**Explanation of Significant Differences  
for the  
100-HR-3 and 100-KR-4 Operable Units  
Interim Action  
Record of Decision**

**Hanford Site  
Benton County, Washington**

**August 2009**

Figure 3. 100-D Area Chromium Plume Conceptual Site Model 1995-2007

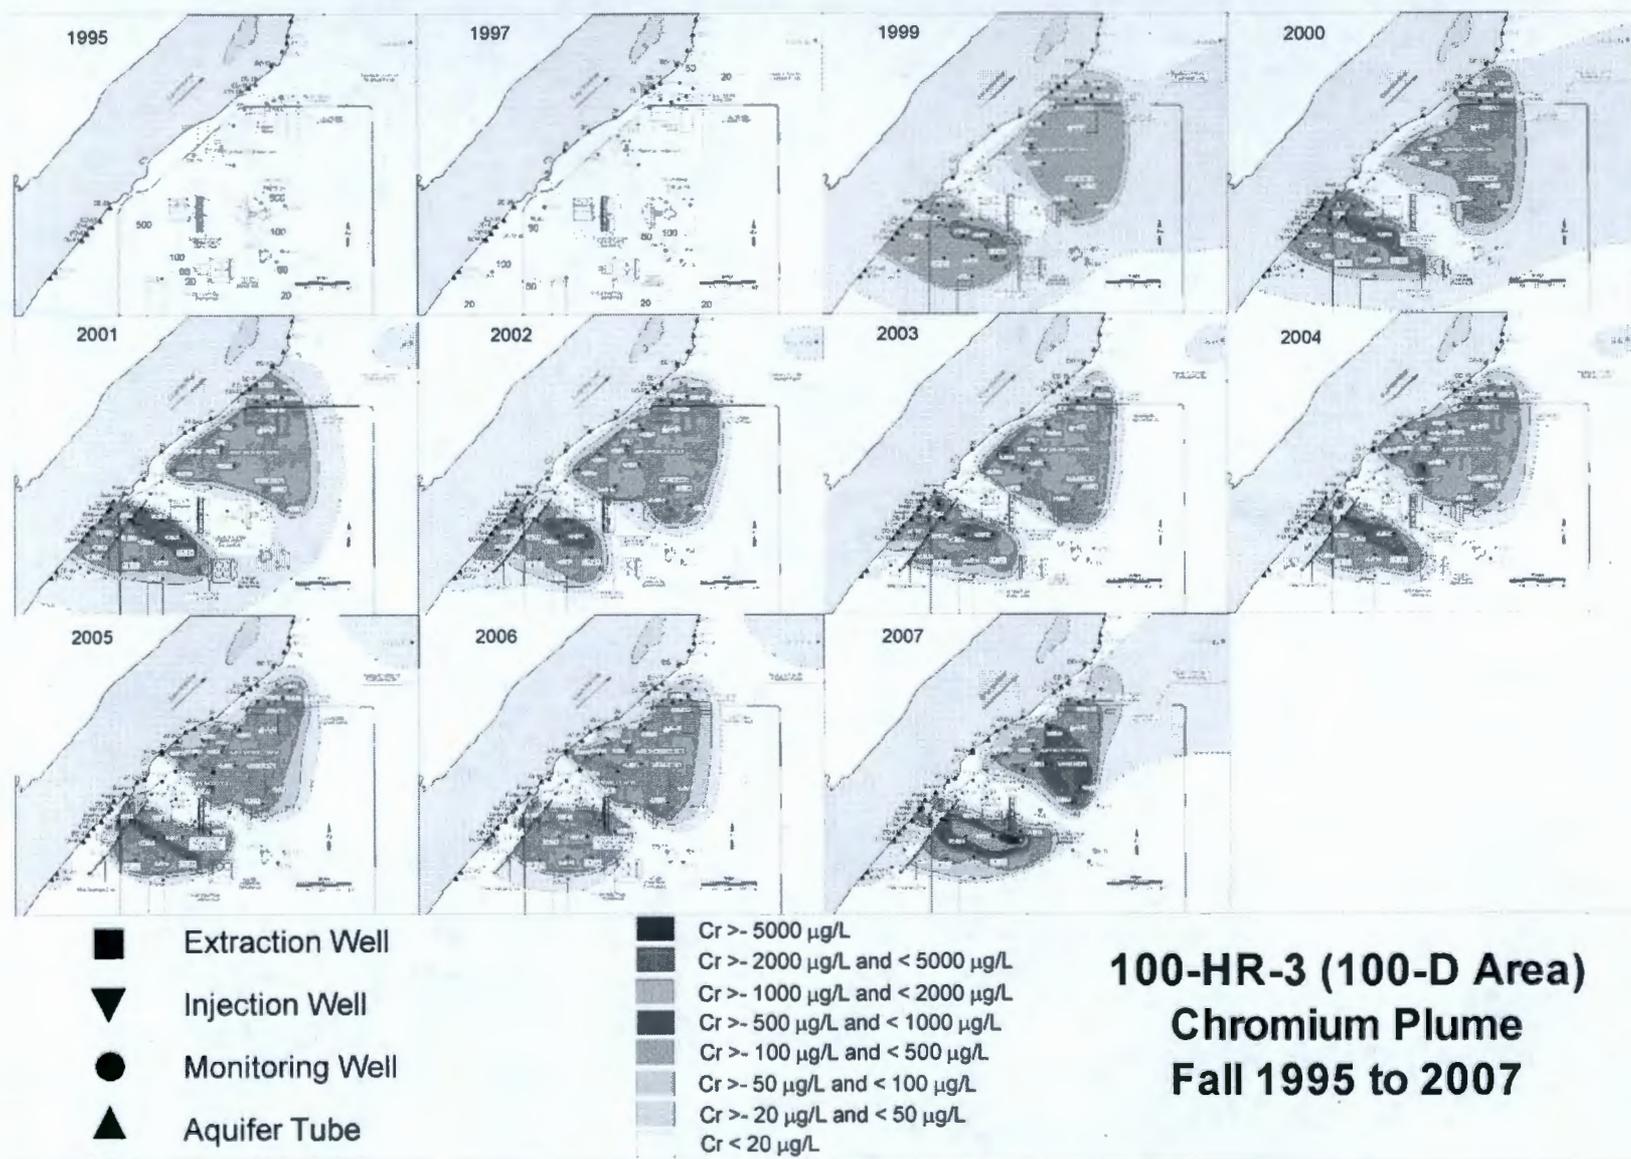
The hexavalent chromium plumes in 100-HR-3 have increased in concentration at the 100-D Area (Figure 3), and have migrated across the Horn Area towards the 100-H Area (Figures 4 and 6). This has required expansion and additions to the pump-and-treat system at 100-HR-3. Process system performance improvements were also implemented in FY2004.

The remedial response at 100-D was originally expected to be a 100 gpm pump-and-treat system. In 2004, a new stand-alone pump-and-treat system, 100-DR-5, was installed to capture a newly identified portion of the hexavalent chromium plume resulting from a source in the central portion of the 100-D Area. The RAO for protection of aquatic receptors in the river bottom substrate from contaminants in groundwater entering the Columbia River has not been met at the 100-D Area. An increase in the groundwater pump-and-treat facility capacity and groundwater extraction rate through expansion of the pump-and-treat system is required and the future cost increase is identified in this ESD.

**Figure 4. 100-H Area Chromium Plume Conceptual Site Model 1995-2007**

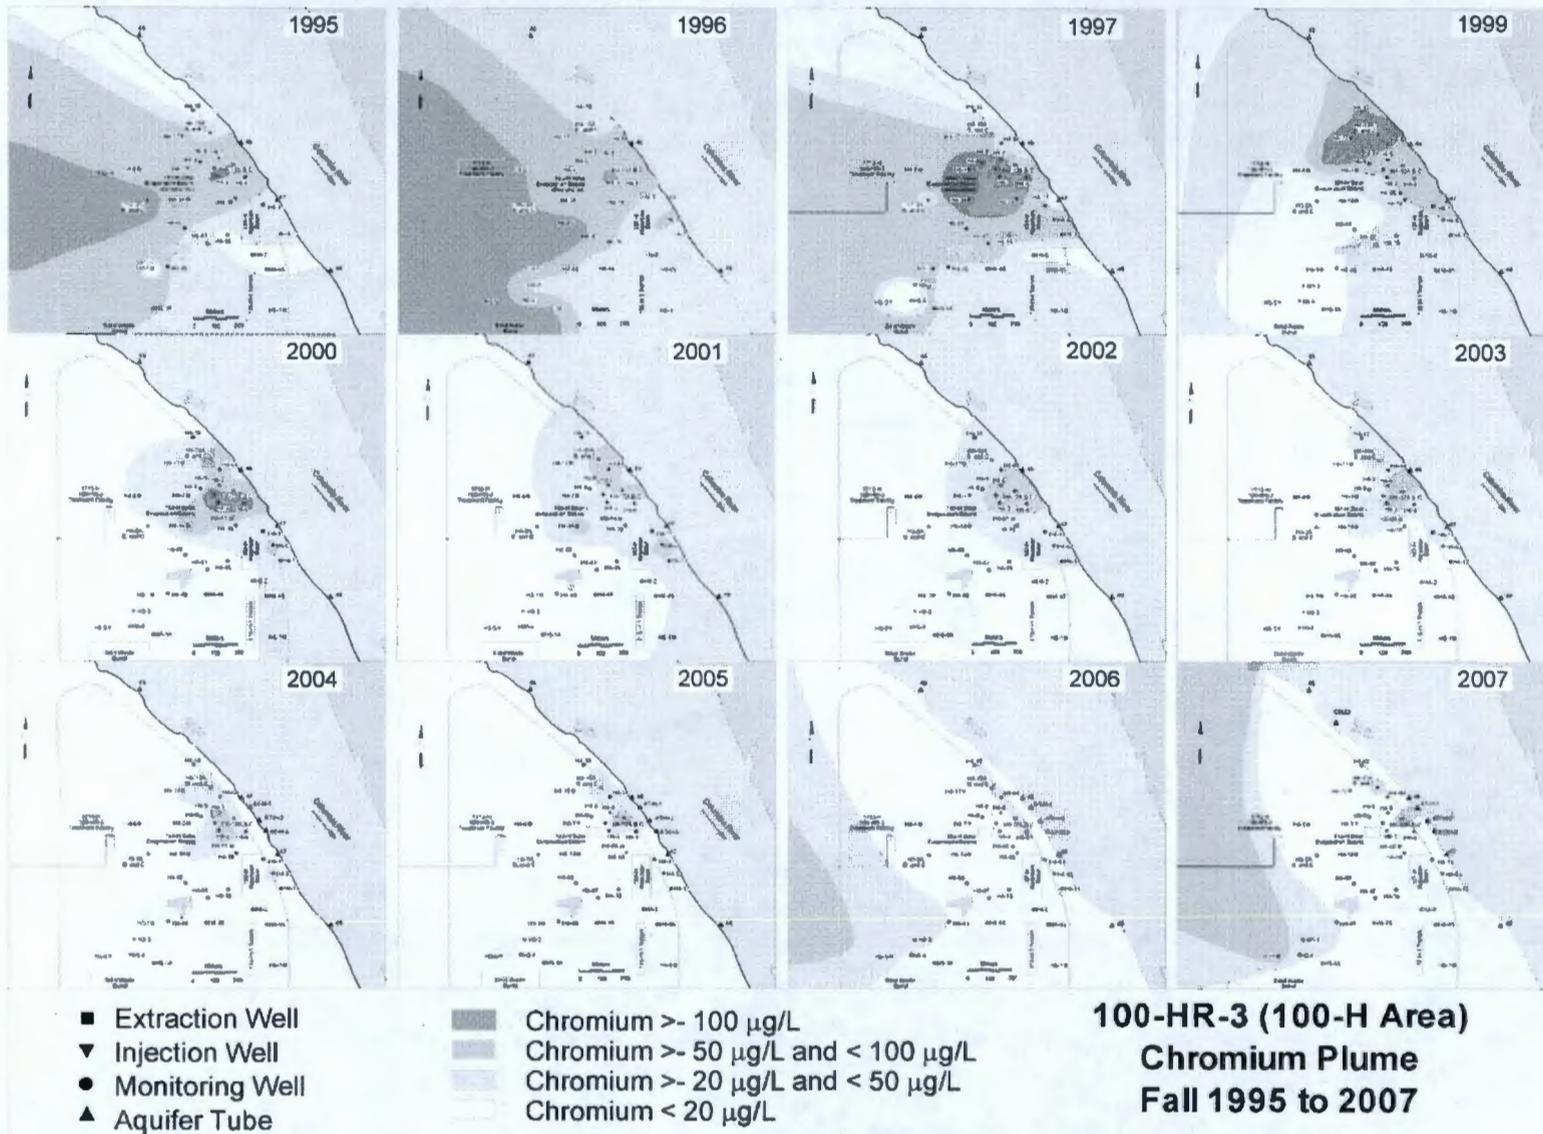
For the 100-H Area, the original pump-and-treat system has been effective at remediating the hexavalent chromium plume in the original target area. The hexavalent chromium plume that migrates east from the 100-D Area is now discharging north of the 100-H area pump-and-treat system. The expansion of the pump-and-treat system for 100-HR-3, identified in the future cost estimates and presented in this ESD, is driven by the need to remediate this plume as well as the plume at the 100-D reactor to meet ROD requirements. The RDR/RAWP for 100-HR-3 will identify the specific changes to the capture system for the 100-HR-3 plume.

Figure 5. 100-K Area Chromium Plume Conceptual Site Model 1997-2007

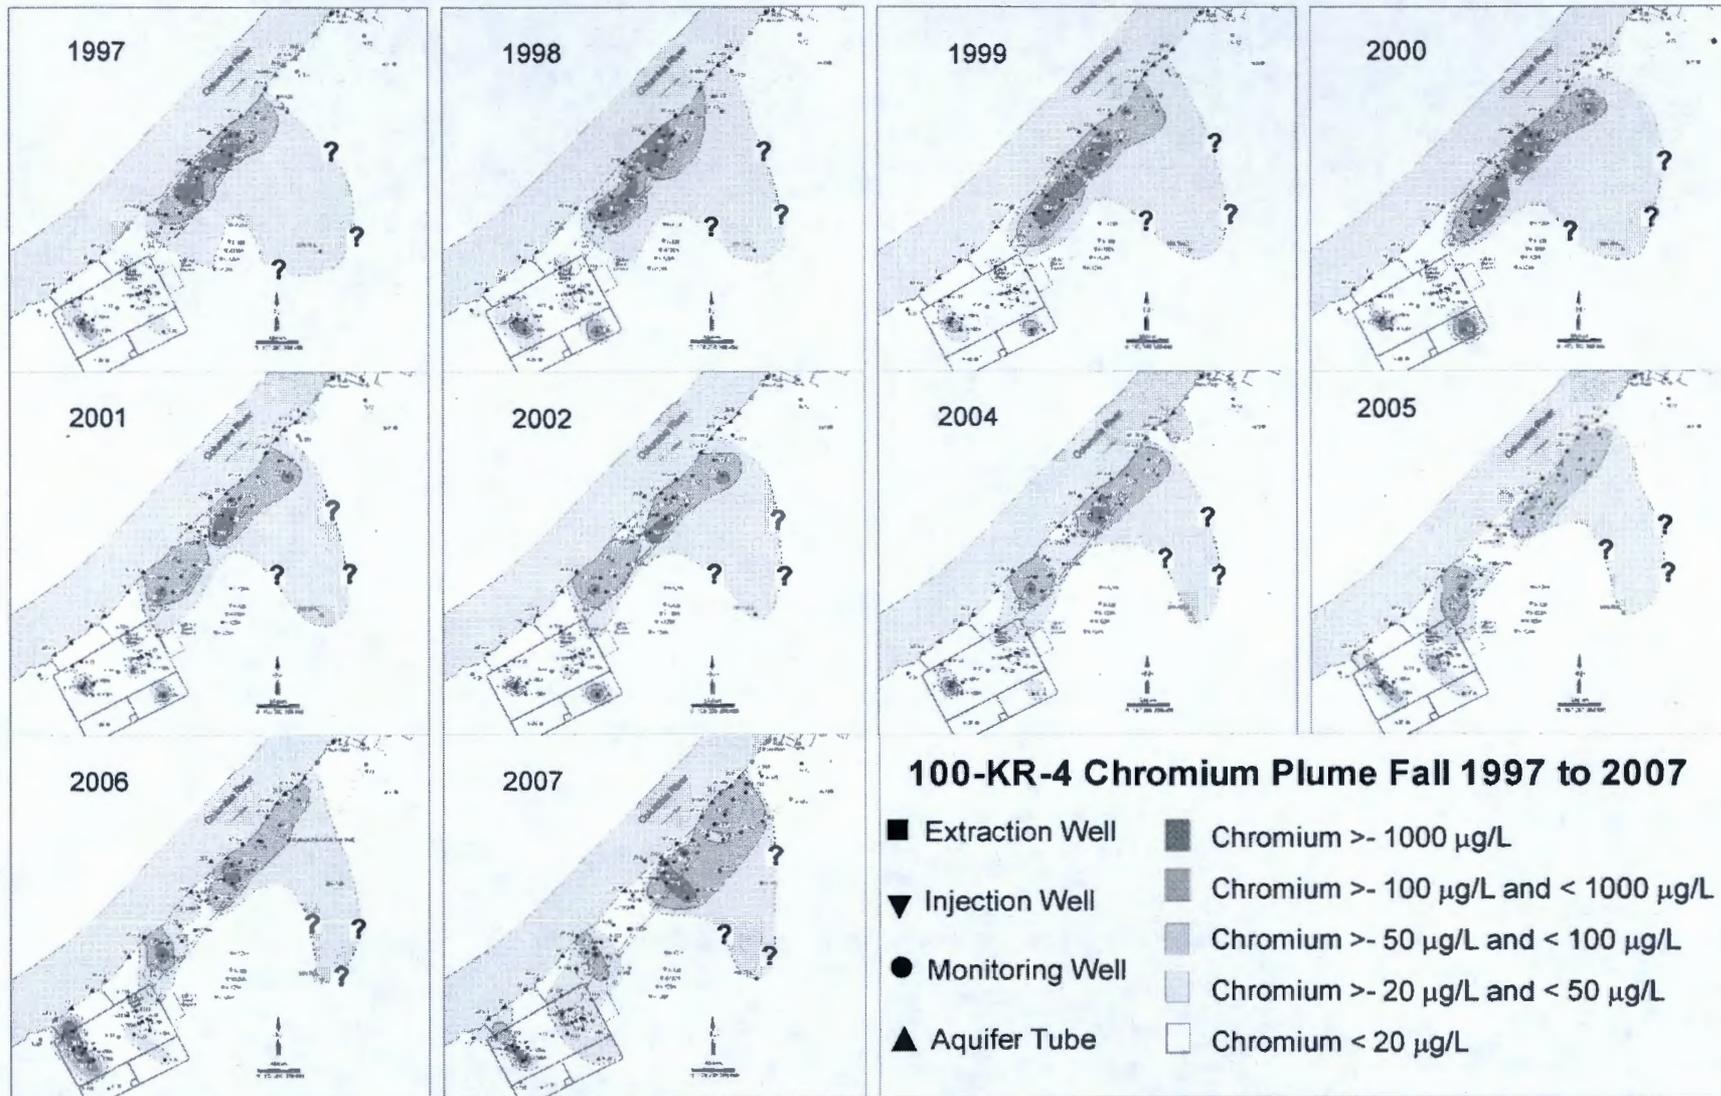
The 100-KR-4 hexavalent chromium plume has expanded to the NE (Figure 5), and the hexavalent chromium concentrations in the groundwater have increased, which required expansion of the pump-and-treat system. The existing treatment system has been expanded to 900 gpm compared to the 220 gpm identified in the 1996 ROD. An expanding plume has developed in the area of the K West reactor. A separate pump-and-treat system was installed in 2007 to remediate that plume. The new 200 gpm treatment capacity for K West began operation in FY09 and will result in increased cost reflected in this ESD. In addition, system performance improvements were implemented, which also increased the cost of the total project.
